Memo: M013-B

Manchester Goods Yard

Acoustic testing schedule

This memo details the proposed Shell & Core acoustic commissioning testing for Manchester Good Yard.

DRAWING TITLE									
GENERAL ARRANGEMENT PLAN - MEZZANINE LEVEL FLOOR PLAN									
1 : 200 @ A1 2 10 20M									
RETURN AIR NO		ISSUE DATE		DRAWN BY		CHECKED BY			
261MGY		NOVEMBER 2018		AE		MD			
PROGRAMMED	DESIGNED	CHECKED	VOLUME	LEVEL	ROLL	NUMBER	REVISION		
SJQ	600	CTA	XX	L00M	DR A	20003	C06

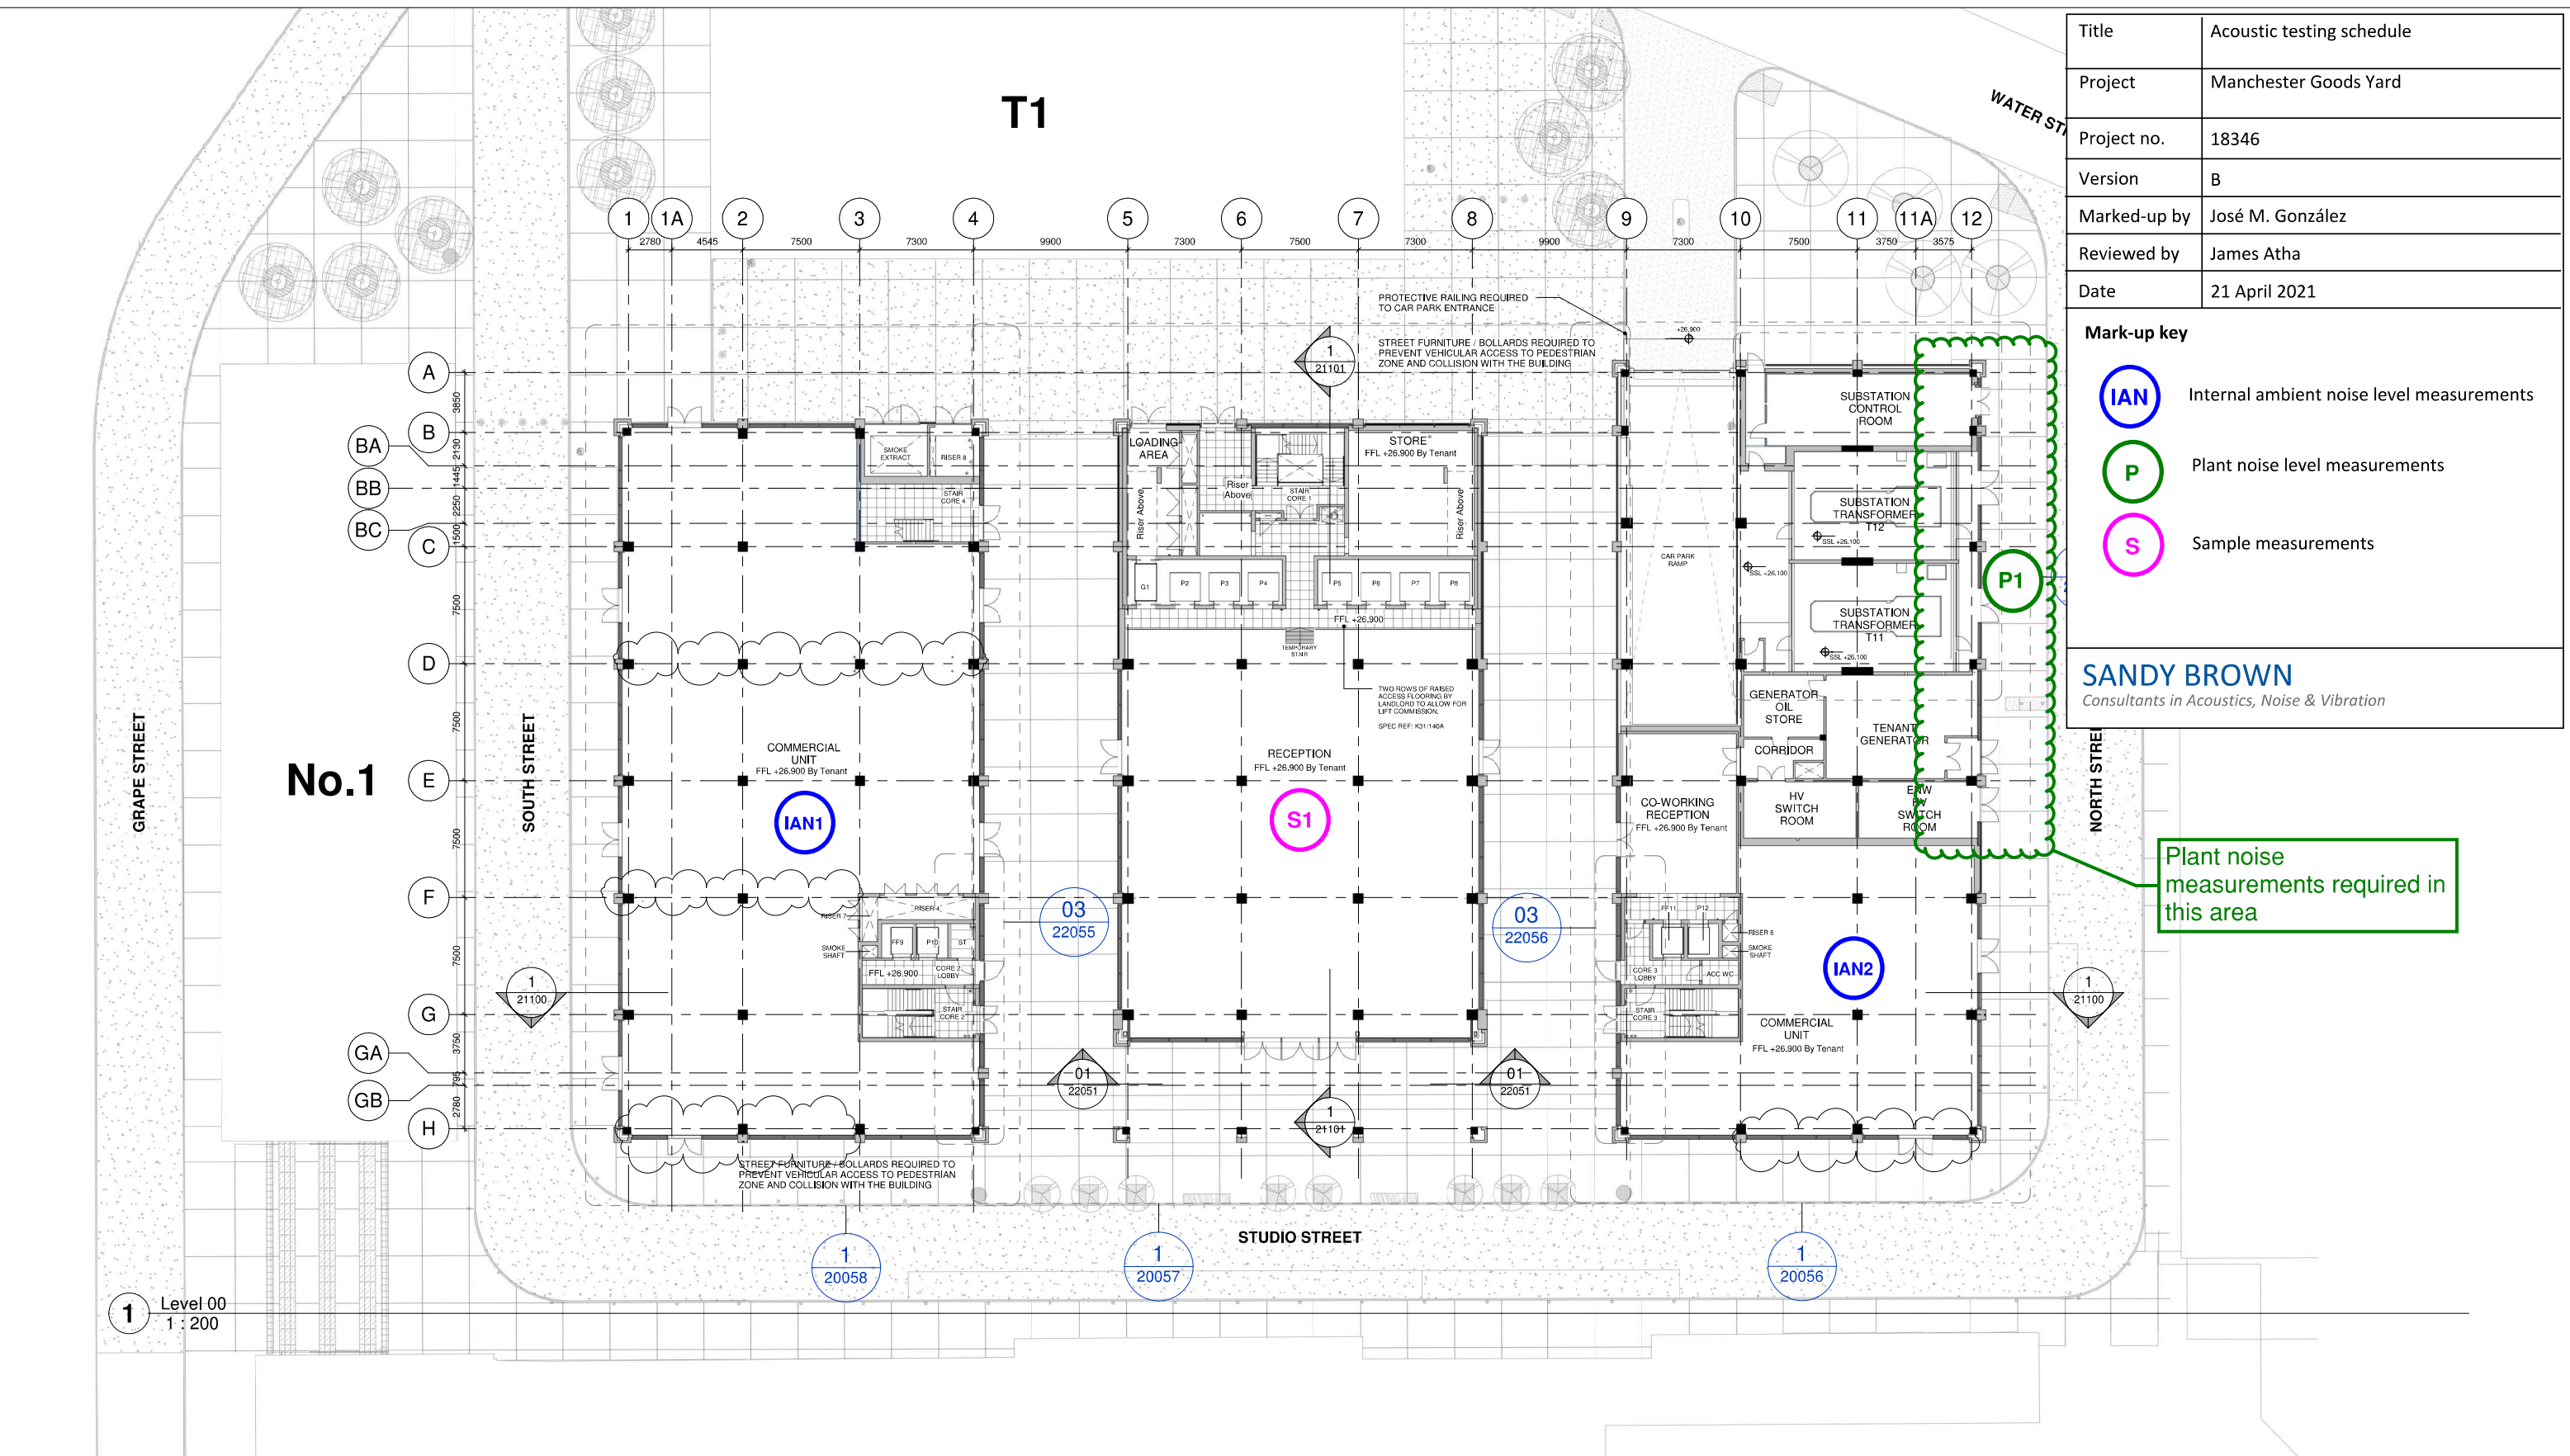
Plant noise measurements required in this area

1 Level 08
1 : 200

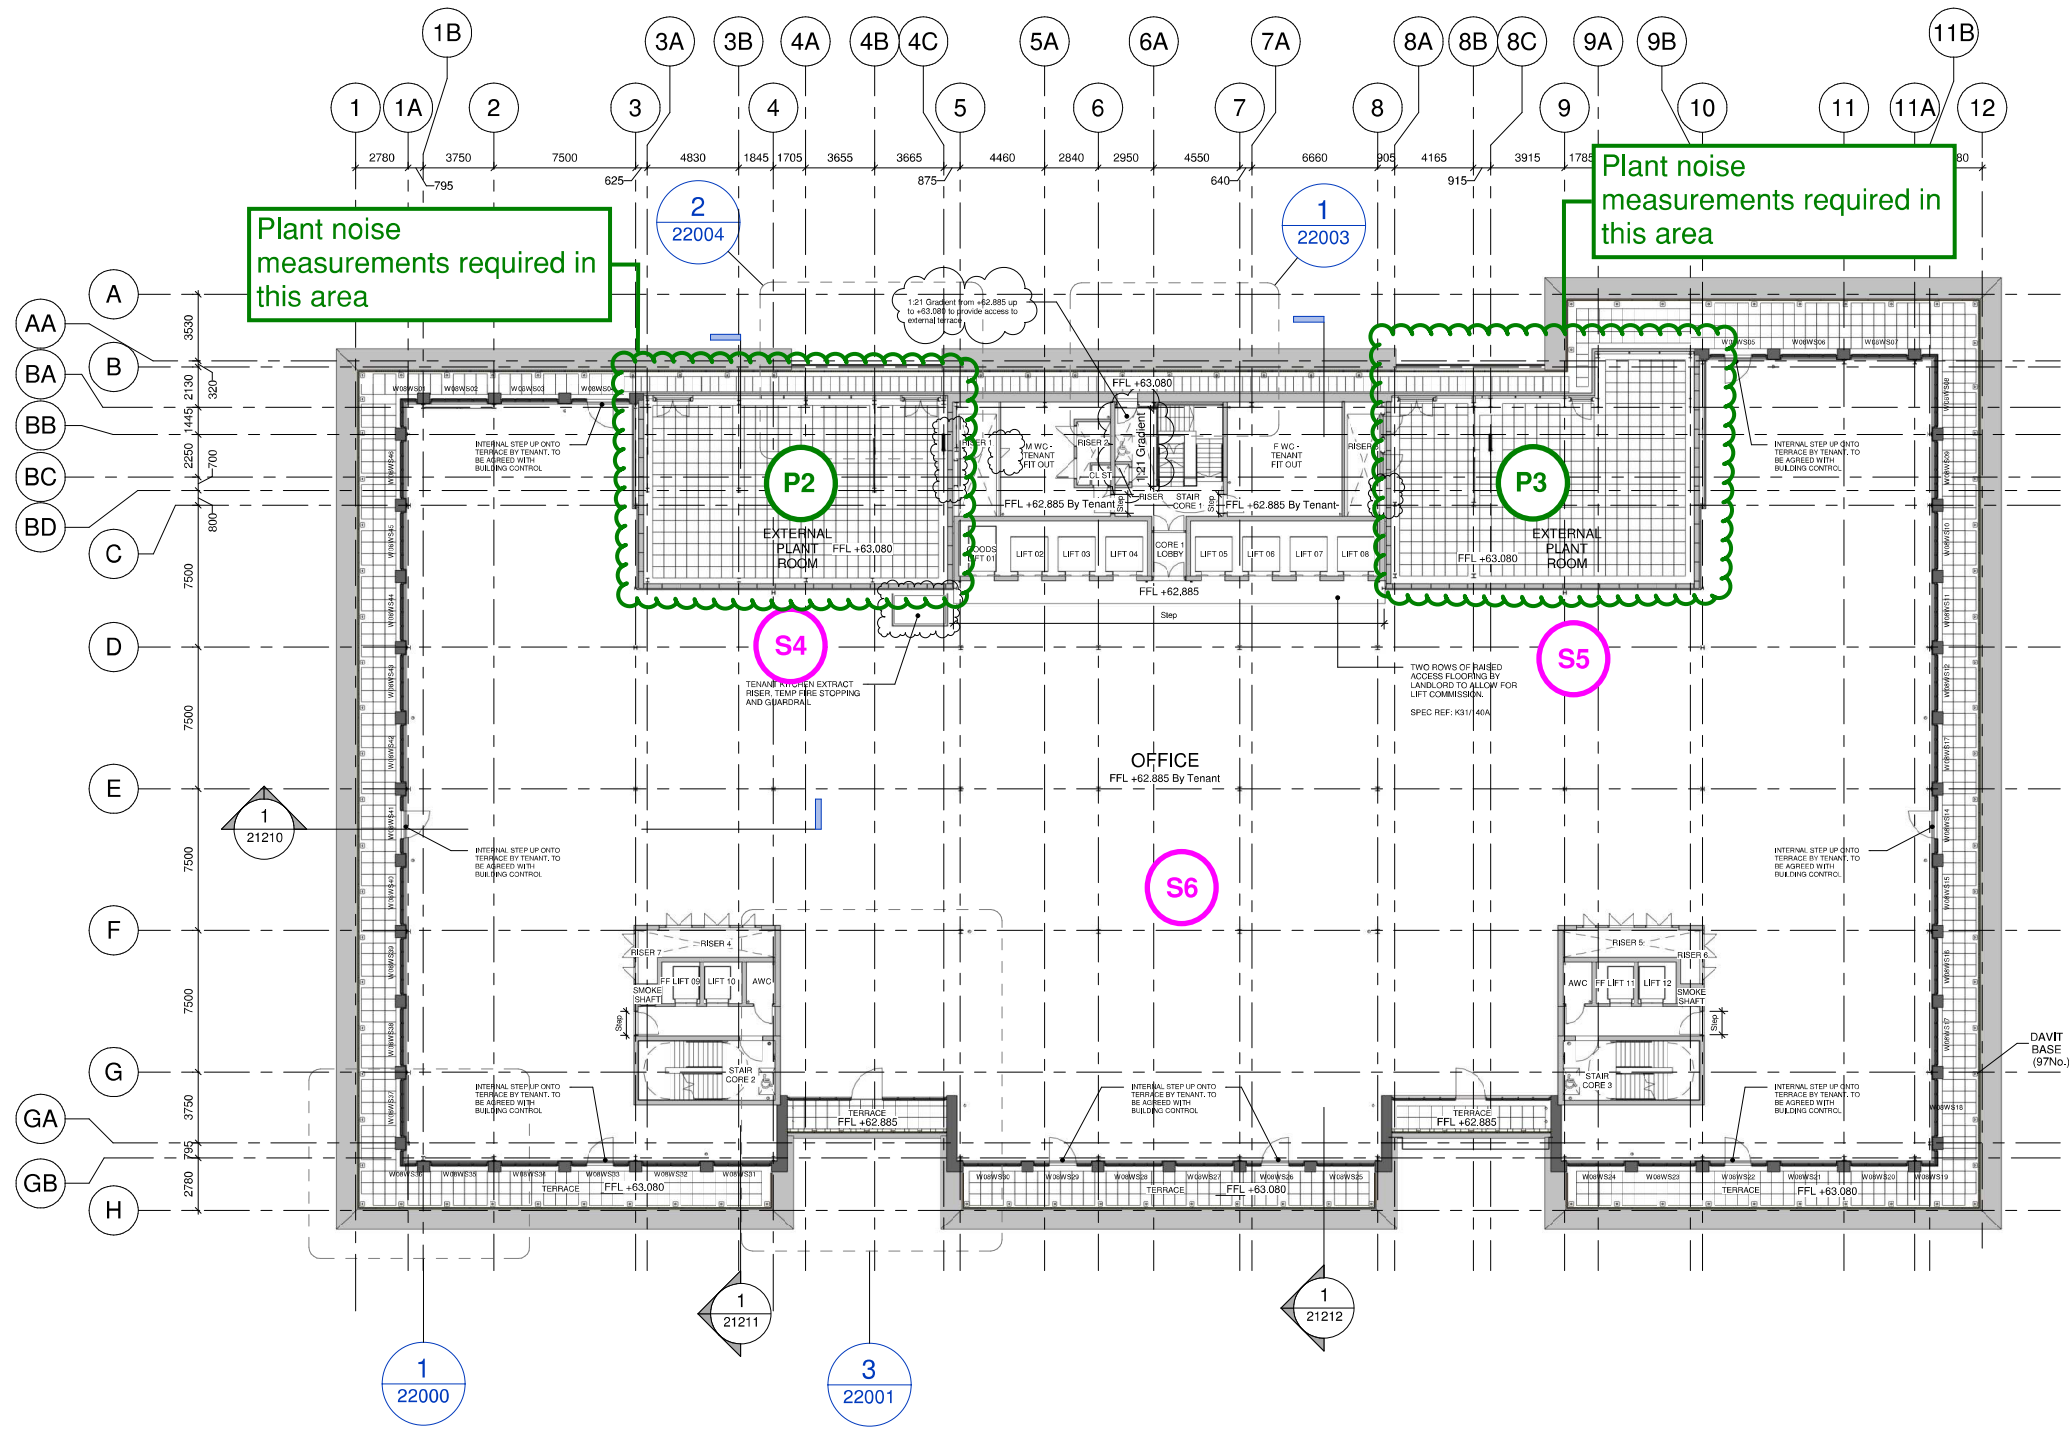
The proposed spaces in which measurements are proposed in line with the BREEAM requirements are indicated as IANL (in blue) in the mark-ups at the end of this memo. In each space 3 x 5 minute noise measurements will be undertaken in line with the methodology set out in the BREEAM Testing, measurement and calculation procedures (pages 113 and 114).

Additional sample noise measurements in spaces of interest are shown as S (in pink) in the mark-ups at the end of the memo.

The proposed spaces in which measurements are proposed are indicated as P (in green), in the mark-ups at the end of the memo. The final measurement locations will be select on-site by the engineer carrying out the measurements.

1 Level 09
1 : 200

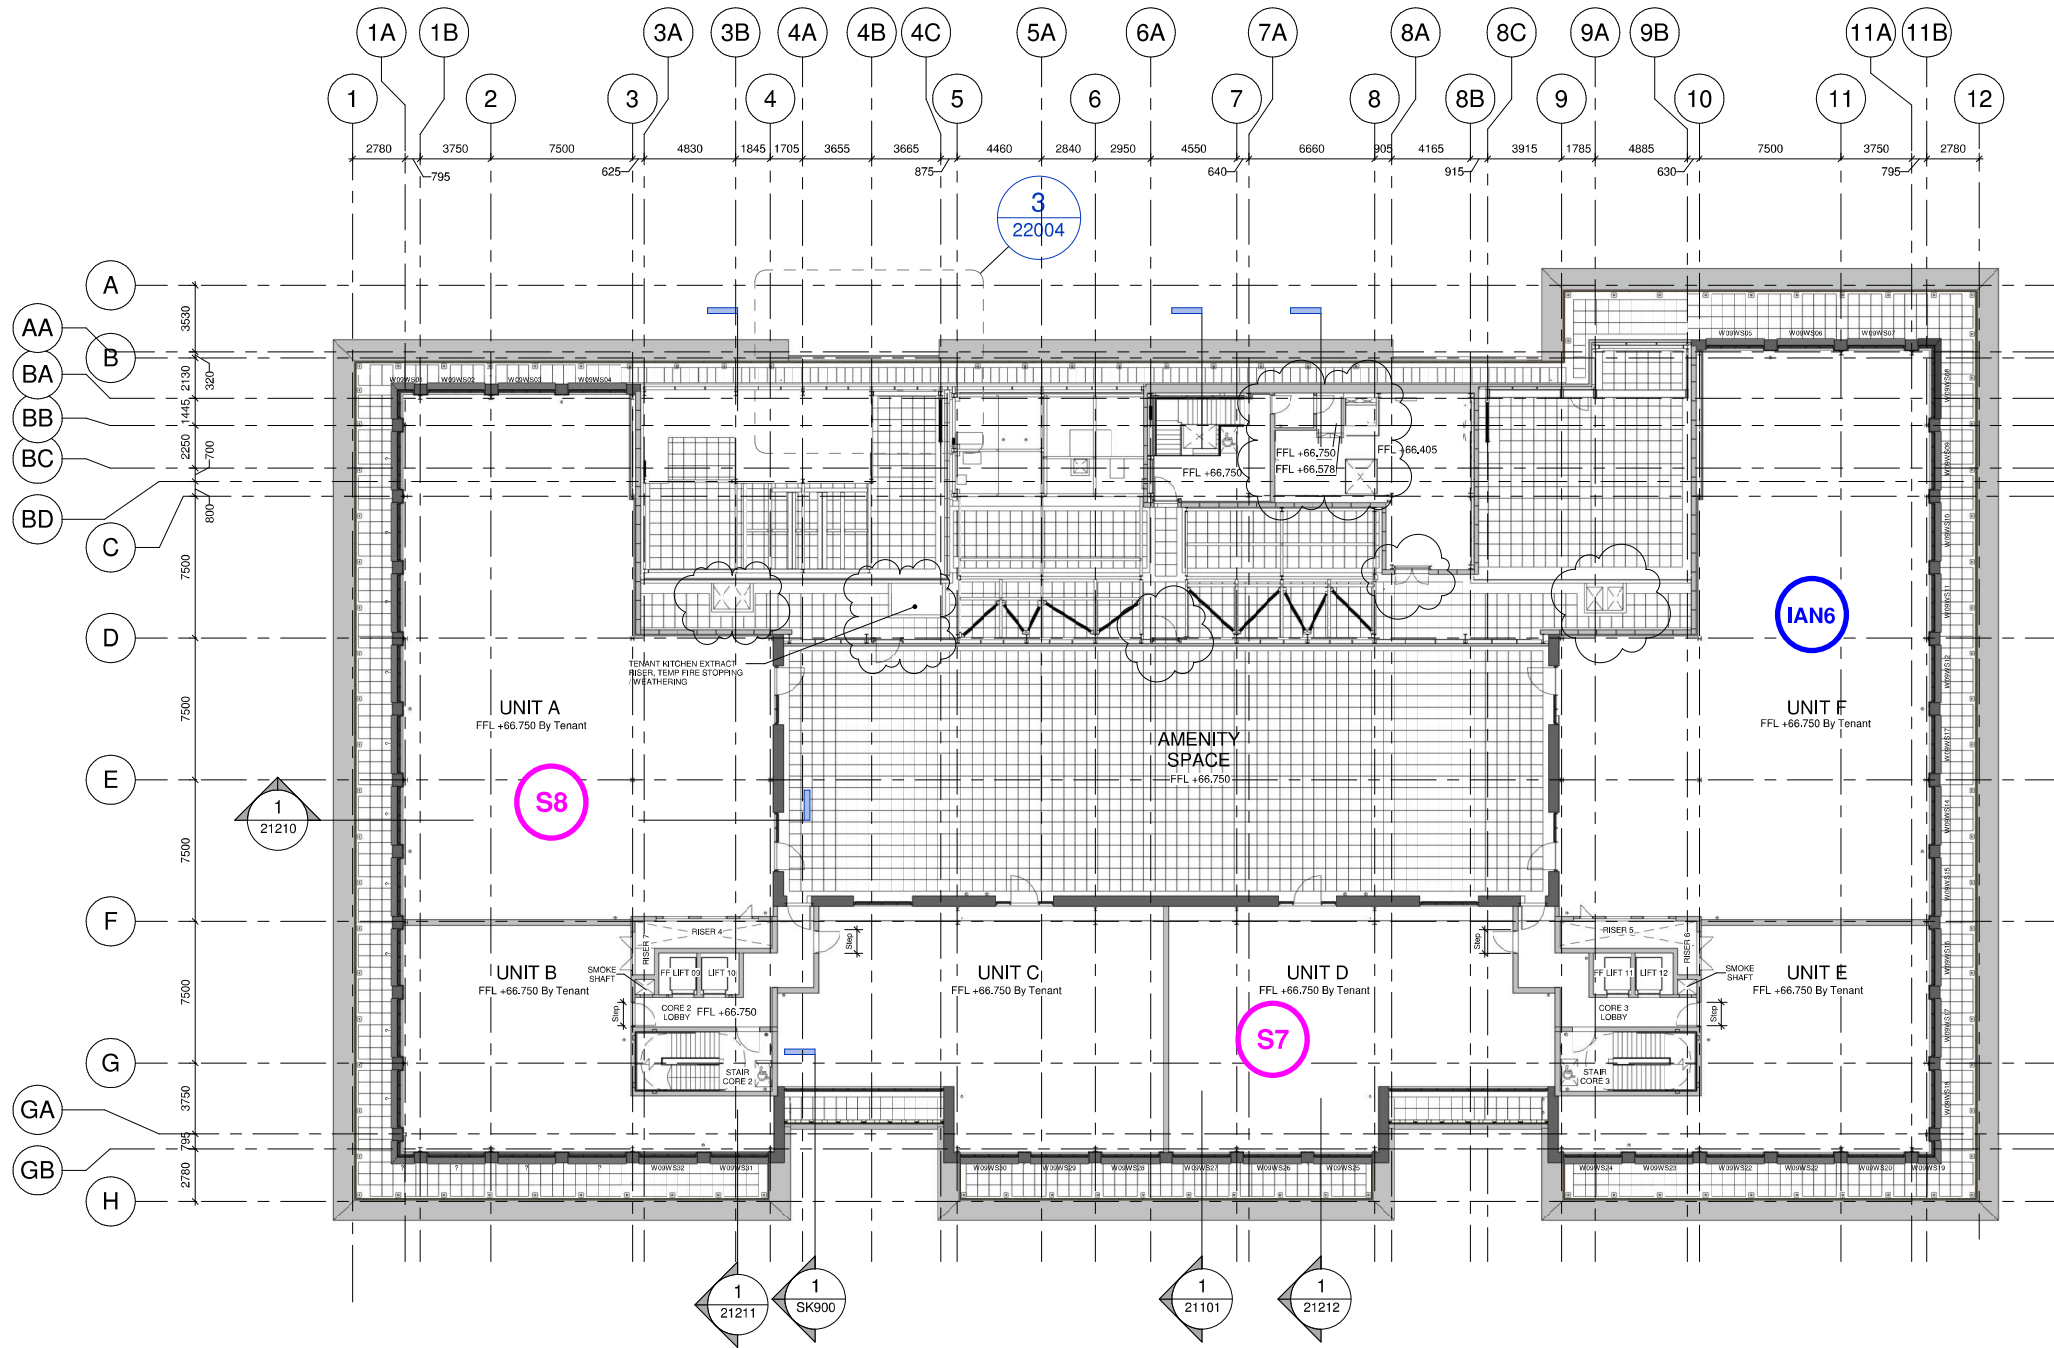
The separating partitions indicated between units A and B, C and D, and F and E at Level 09 have been omitted, therefore no sound insulation testing are proposed.
